Document #: SD-WM-ATR-119

ACCEPTANCE TEST REPORT FOR CORE SAMPLE TRUCKS 3 &  
4

Abstract: This report documents the successful completion of acceptance testing for the Rotary Mode Core Sampling (RMCS) trucks 3 & 4. The report includes a test report summary, and the test procedure (WHC-SD-WM-ATP-119), data sheets, and exception resolutions for each truck.

Figure 15) Instrumentation Display Panel.

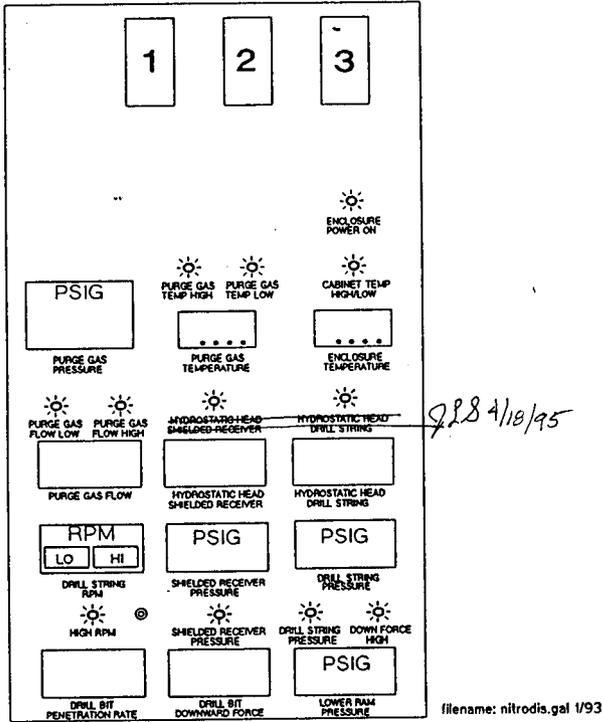
7.4.2.5.12	In Note: Change outward to inward and inward to outward.	Typographical error	<i>[Signature]</i> MME 6/30/95
	7.5	Remove "Hydrostatic head shielded receiver" and "Hydrostatic head drillstring" labels from Figure 15.	Hydrostatic head flow monitoring equipment was removed when the hydrostatic head flow meters were replaced.	<i>[Signature]</i> MME 6/30/95

Figure 16) Purge Gas Controls.

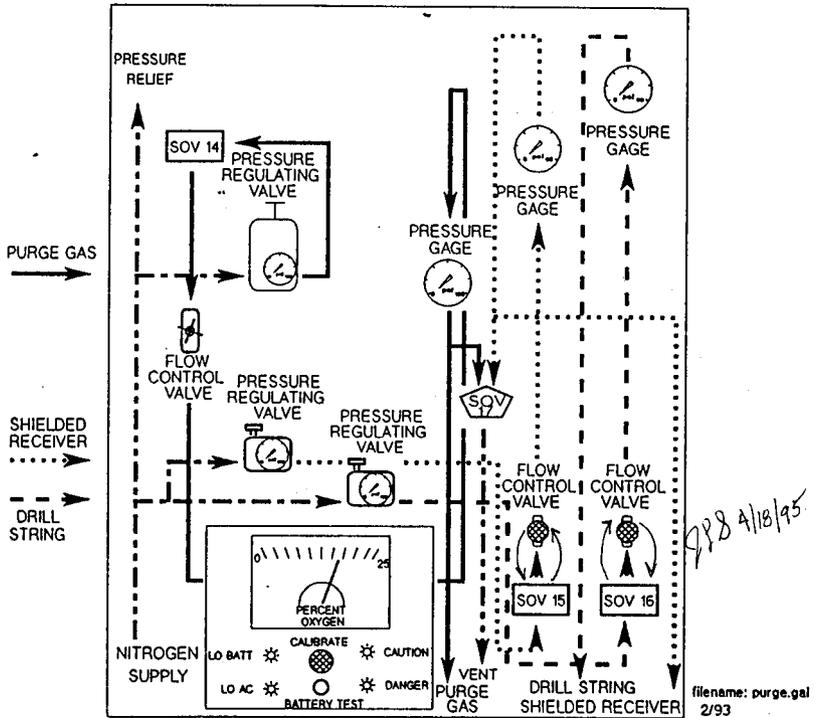
7.5	Swap SOV15 with flow control valve and SOV16 with flow control valve in figure 16.	Schematic changed when hydrostatic head flowmeters were replaced with mechanical flow control valves.	<i>[Signature]</i> MME 6/30/95

Figure 15) Instrumentation Display Panel.

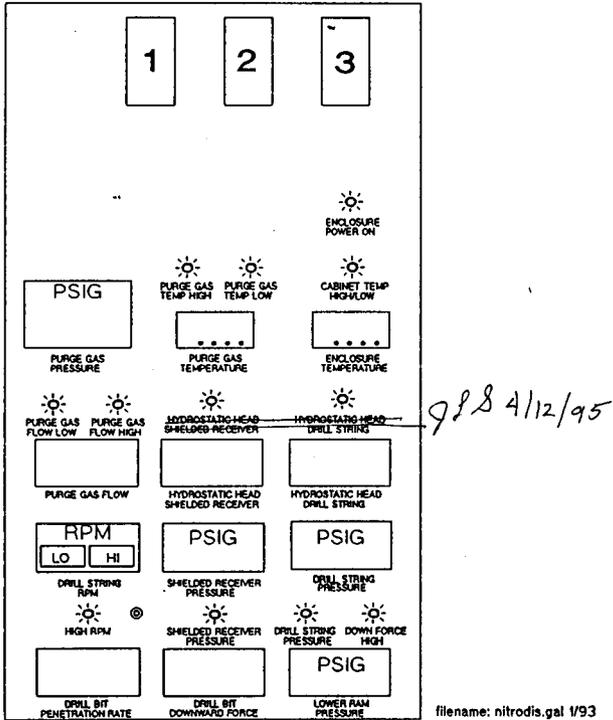
7.4.2.5.12	Changed Outward to Inward and Inward to Outward.	Typographical error.	<del>MM</del> MM 6/30/95
	7.5	Removed following labels from Figure 15. "Hydrostatic head Shield Receiver" and "Hydrostatic head Drill String".	Hydrostatic head flow monitoring equipment was removed when the hydrostatic head flow meters were replaced.	<del>MM</del> MM 6/30/95

Figure 16) Purge Gas Controls.

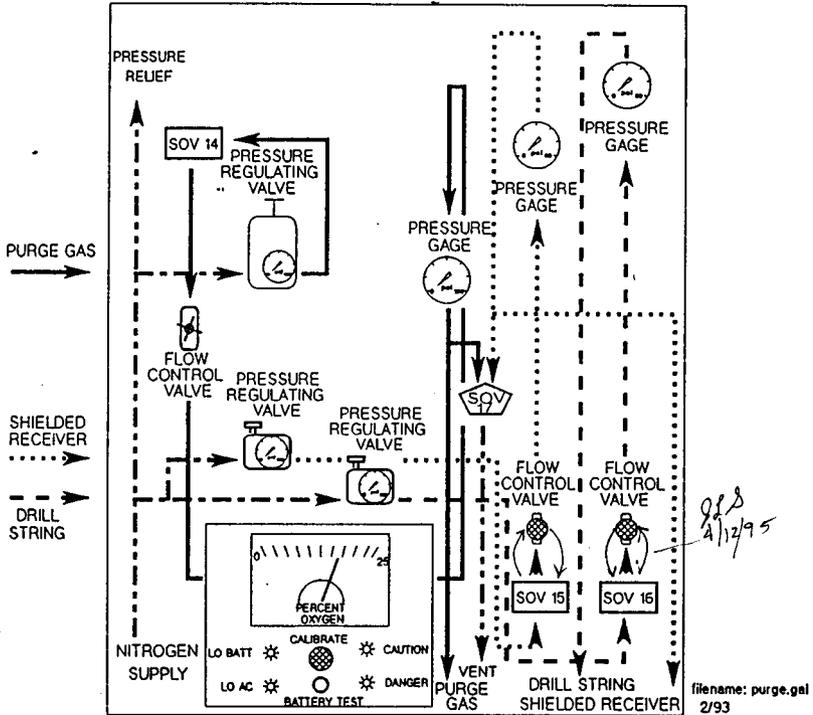
7.5	Swapped components in Figure 16. Swapped SOV15 and associated flow control valve and SOV16 and associated flow control valve.	Schematic changed when hydrostatic head flowmeters were replaced with mechanical flow control valves.	<del>MM</del> MM 6/30/95
